**TOWN OF LOS GATOS
PLANNING COMMISSION AGENDA
MAY 12, 2021
110 EAST MAIN STREET
LOS GATOS, CA**

2. Requesting Approval for Demolition of an Existing Single-Family Residence and Construction of a New Single-Family Residence on Property Zoned R-1:8 Located at **140 Arroyo Grande Way**. APN 424-23-048. Architecture and Site Application S-20-013. Property Owner/Applicant: Yogesh Jhamb. Project Planner: Sean Mullin.

DATE: May 7, 2021
TO: Planning Commission
FROM: Joel Paulson, Community Development Director
SUBJECT: Requesting Approval for Demolition of an Existing Single-Family Residence and Construction of a New Single-Family Residence on Property Zoned R-1:8 Located at 140 Arroyo Grande Way. APN 424-23-048. Architecture and Site Application S-20-013. Property Owner/Applicant: Yogesh Jhamb. Project Planner: Sean Mullin.

RE: Plan Updates – 140 Arroyo Grande Way (S-20-013)

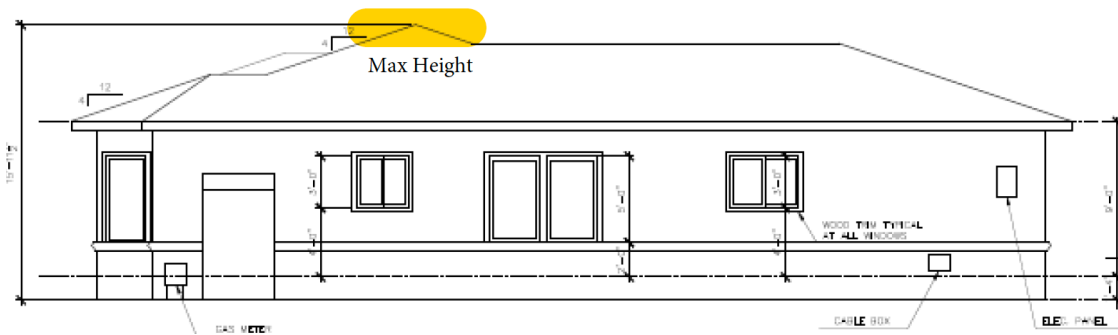
While the new home is 3' taller than the original home, the side elevation given below shows that this maximum height is only reached at a certain point and the majority of the roof is at 14' or less from grade level. This was done primarily to address the sky-view concerns of our neighbors to the right at 124 Arroyo Grande Way.

2. Landscape

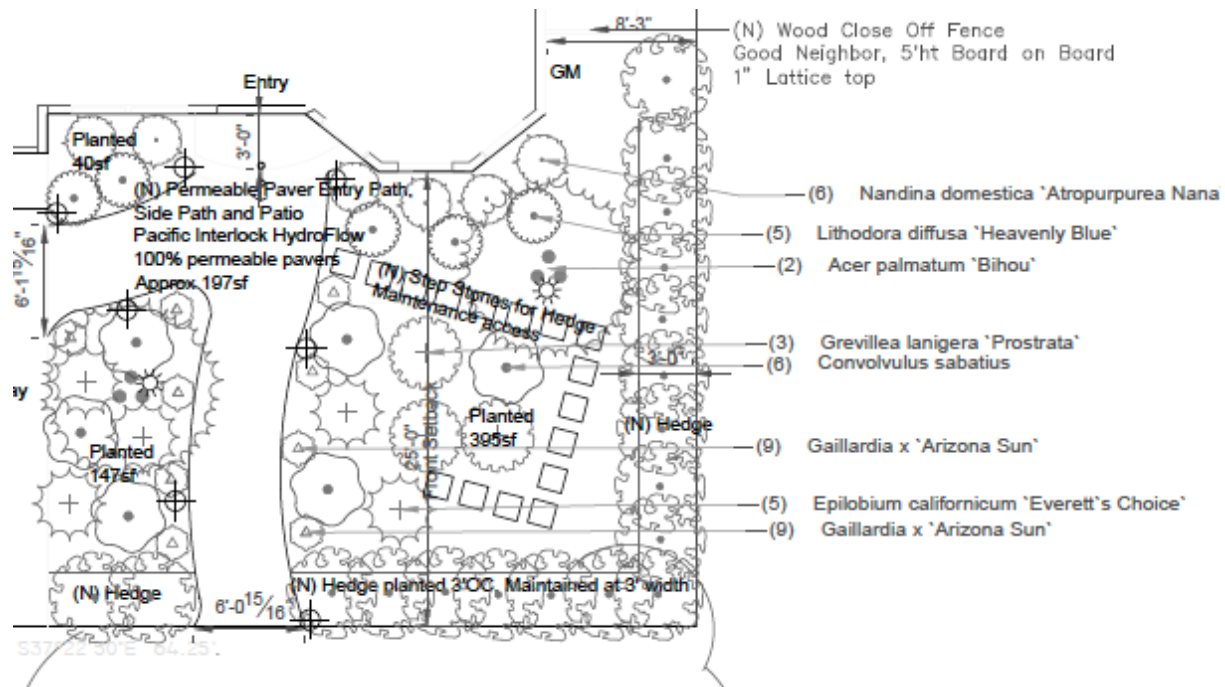
We are working with a landscape architect to design a garden in the front of our home. The garden in our front-yard will have drought-resistant and low-water usage plants and shrubs with a view towards water conservation. An image of the plan showing the front-yard is given below.

RIGHT SIDE ELEVATION

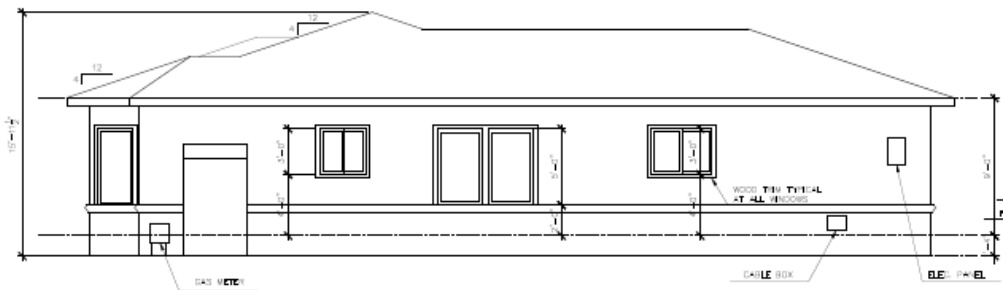
- b. Privacy: We value the privacy of our neighbors. We have lowered all windows by 1' to address the privacy concerns of our neighbors. The neighbors at our back are at a 2' higher grade level, which effectively makes the fence 8' tall (see image below). We have explained this to our neighbors at the back and they have not raised any more concerns.

We have limited the number of windows on both the side elevations. The right elevation has only one bedroom window and the remaining two are bathroom windows.

LEFT SIDE ELEVATION

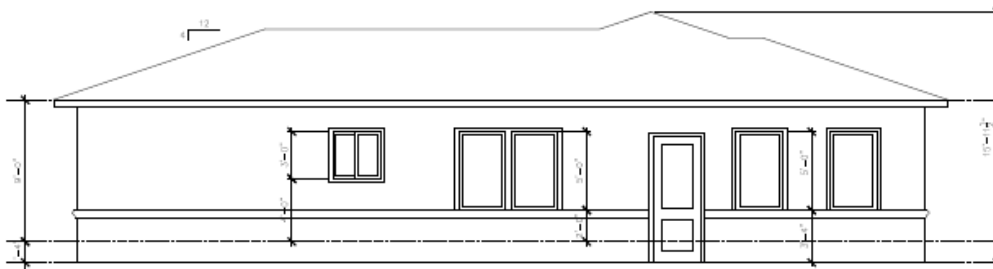
The left elevation has 2 garage windows; however, they don't face a living area and our neighbor has no windows in their garage. There is one media room window and one bathroom window on the right-side elevation.

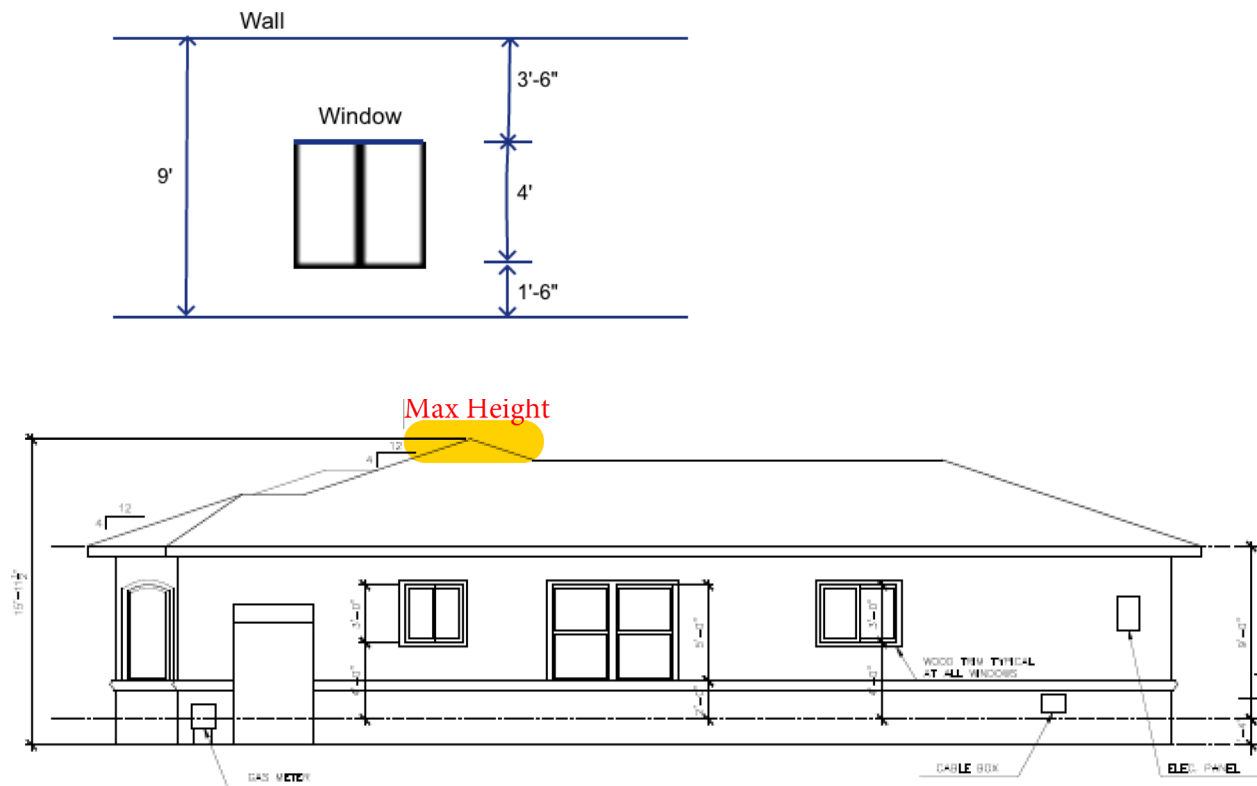
"Lower windows - we appreciate your reducing your windows, but the fence and our top-down/bottom-up blinds mitigate our privacy concerns if you would like to raise the windows back up."

The bedroom window on our side elevation towards your home does not align with any of your windows. The remaining two windows are bathroom windows, which will have no visibility. We have attached an image that indicates how a 4' window would look with the top of the window at 5'-6" from floor level to be aligned with the top of the fence at 7'. As you can see, this results in the window being too low on the wall. We hope you can understand that we value your privacy and that there is no way for us to look over the fence standing at the floor level.

The applicant has lowered the plate height and corresponding eave height by one foot.

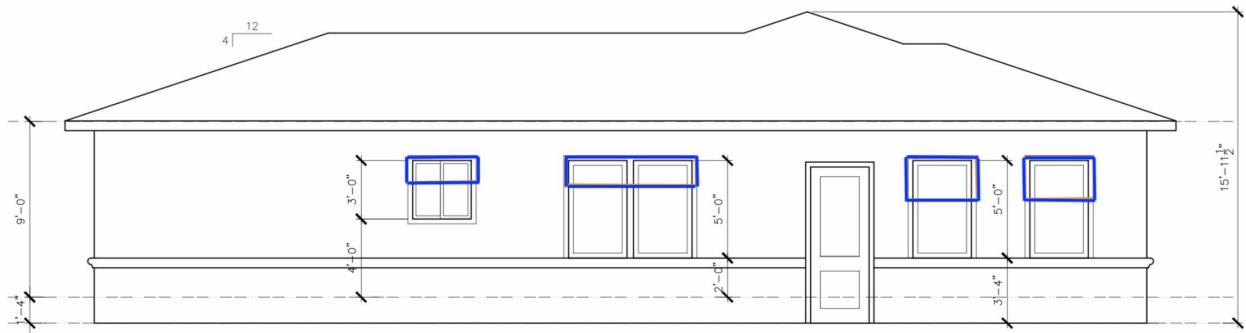
Following the meeting of March 24, 2021, the applicant revised the development plans to incorporate all the recommendations of the Town’s Consulting Architect and to address the Planning Commission’s comments (Exhibits 13 and 15). The story poles have been updated and an updated project sign has been posted in accordance with Town policy.

1. Figure 1: The plan has five windows facing to my side. All windows are higher than the fence 1'-2' (Blue area).
2. Figure 2: The media room has a huge double window. It's almost as large as a backyard slide door (Blue area).
